FERC AFTER ACTION PANEL

ASSESSMENT OF OROVILLE SPILLWAY

November 23, 2018

Fig. 2.3.1 Possible Slab Settlement and Resulting Offset Into Flow

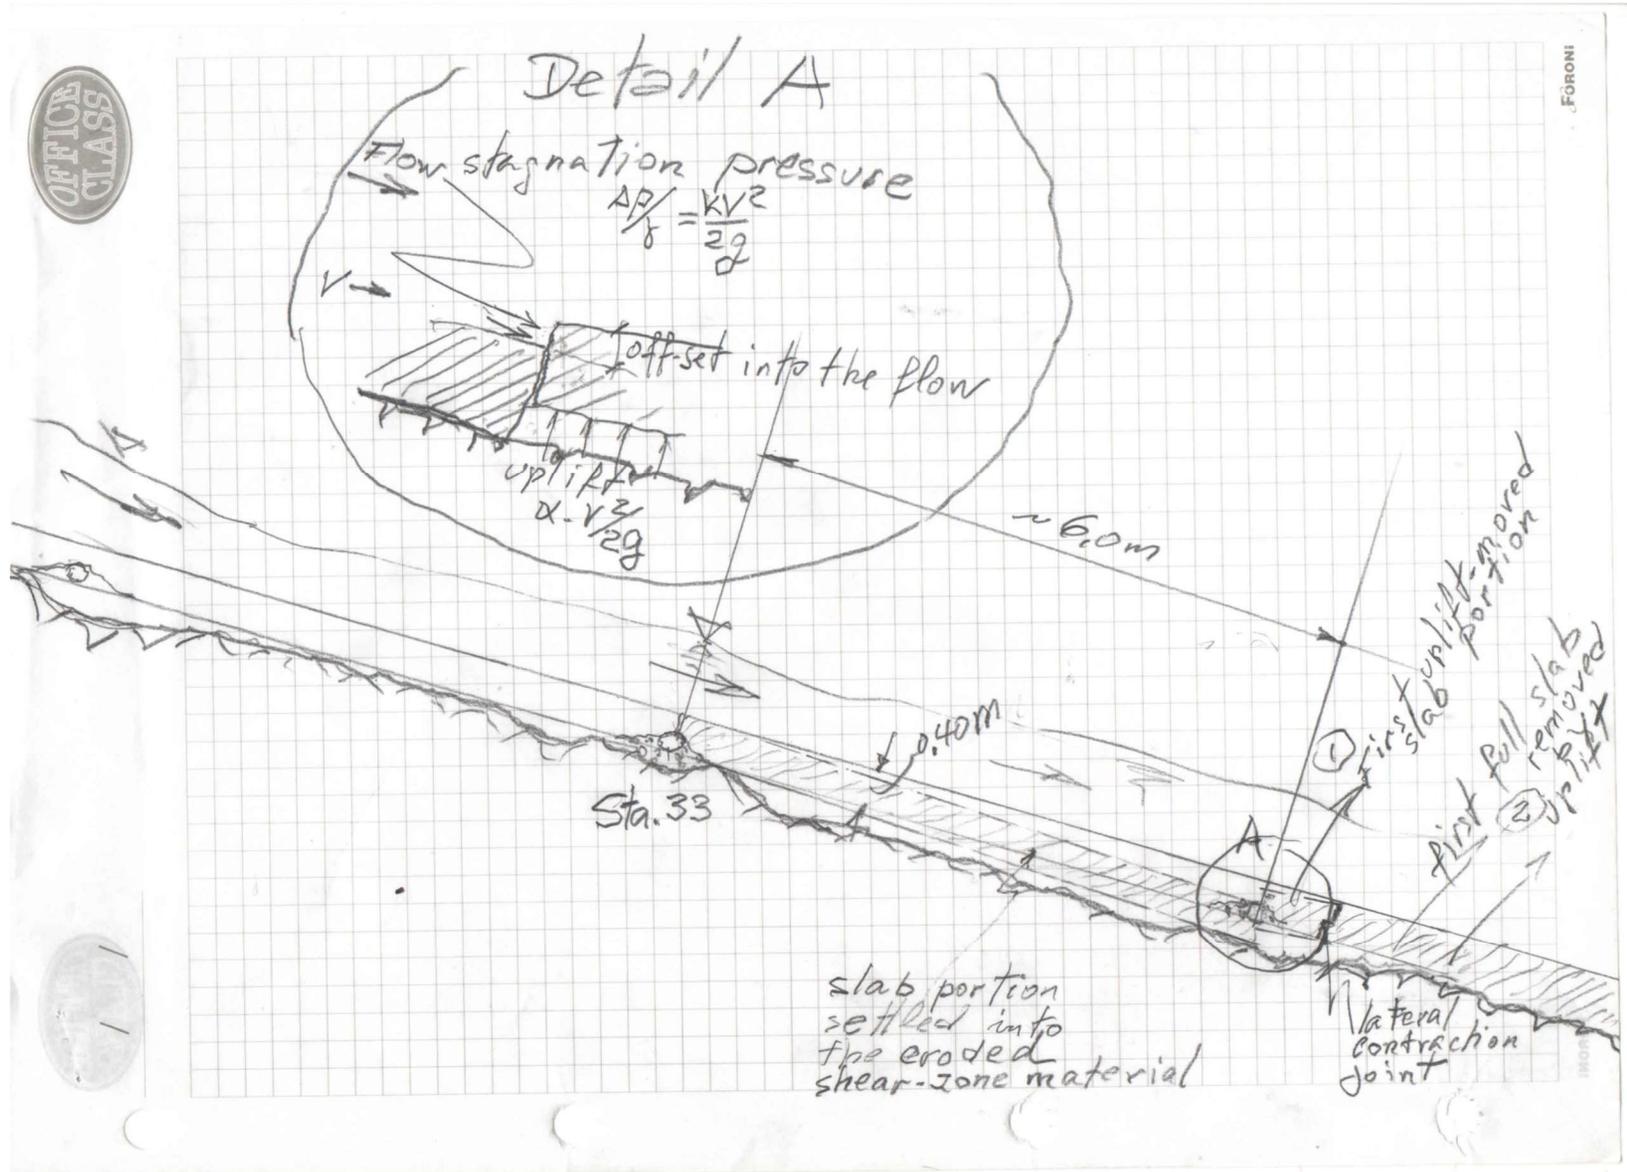
2. The second physical cause mechanism was the sudden increase of the uplift force under the slab, induced by an offset into the flow, resulting from the slab settlement of February 7, 2017.

The stagnation pressure of the high velocity shooting flow against this offset (a high proportion of the velocity head), propagated under the slab through vertical cracks and/or joints, producing a large uplift force that raised and dislodged part of the slab. The high stagnation pressure produced a water-splashing phenomenon captured in photos by an operator as shown in Fig. 2.3.2. The earliest photos were probably taken after the initial removal of a portion of the slab. The splashing effects were probably too small to be noticed in the early stages but became clearly visible as the slab removal process developed and the resulting offset into the flow increased.

**Fig. 2.5.1 (IFT, p. 14)**

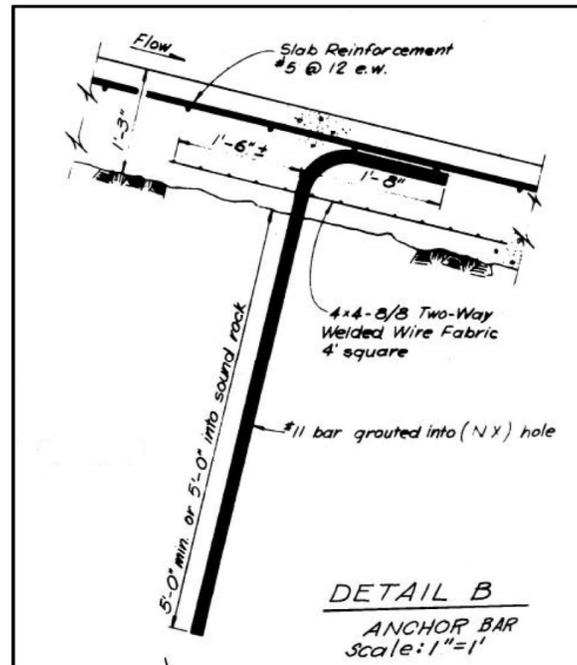
It is important to note that the dimension shown for the anchor bar length in Fig. 2.5.1 specifically indicates that the anchor bar should extend a minimum of 5 ft. from the top of the rock or 5 ft. into sound rock. This was clearly ignored, or violated, in the area of the failure where anchors were drilled into weathered rock / soil like material where the design capacity was severely compromised.
